UNITED STATES
DEPARTMENT OF THE INTERIOR
BUREAU OF LAND MANAGEMENTFORM APPROVED
OMB NO. 1004-0135
Expires: July 31, 2010**SUNDRY NOTICES AND REPORTS ON WELLS**
*Do not use this form for proposals to drill or to re-enter an abandoned well. Use form 3160-3 (APD) for such proposals.***SUBMIT IN TRIPLICATE - Other instructions on reverse side**

WELL NAME: Continental APJ Federal #3 FIELD: Diamond Tail
 LOCATION: 660' FNL & 660' FWL of Section 28-23S-32E Lea Co., NM
 GL: 3,694' ZERO: _____ KB: 3,709'
 SPUD DATE: 1/3/03 COMPLETION DATE: 3/5/03
 COMMENTS: API No.: 30-025-36049

Conditions of Approval

**Yates Petroleum Corporation
Continental APJ - 03, API 3002536049
T23S-R32E, Sec 28, 660FNL & 660FWL
November 15, 2016**

Current:

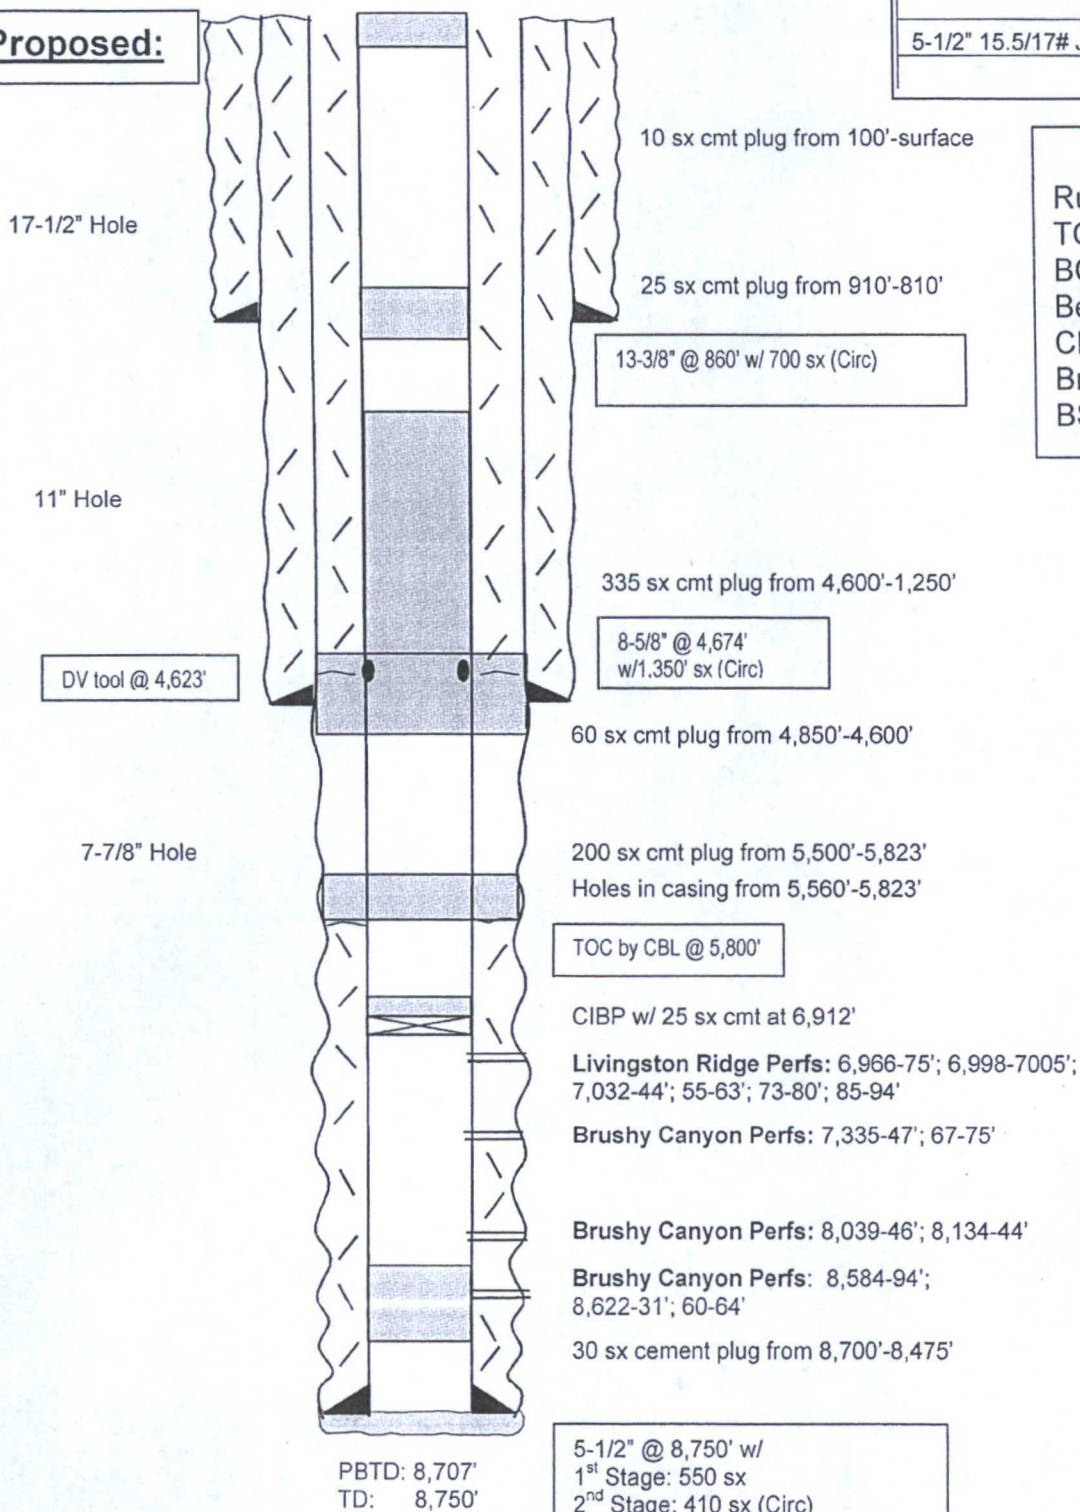
14. Minimum requirement for mud placed between plugs is 25 sacks of salt water gel per 100 barrels in 9 lb/gal brine.
15. **Tag the csg leak squeeze <5560-823> (Step 2 of Yate's procedure) with tubing and pressure test the squeeze plug to 300psig surface pressure.**

16. **Step 3 of procedure: Perf at 4940' or below (50' below Bell Canyon top of 4880).**
17. **After displacement of the 4940 perf sqz, leave the pkr set and close a valve on the tubing at the wellhead. WOC - Hold the cement sqz in place with the displacement fluid until cement has set.**

18. **Release packer. Tag the plug at 4830' or above with tubing.**
19. File **subsequent sundry** Form 3160-5 within 30 days of workover procedures. Submit the (BLM Form 3160-5 subsequent report (daily reports) via BLM's Well Information System; <https://www.blm.gov/wispermits/wis/SP> (email pswartz@blm.gov for operator setup instructions). Include (dated daily) descriptions of the well work, ie. procedure descriptions and setting depths of each plug in the subsequent sundry.
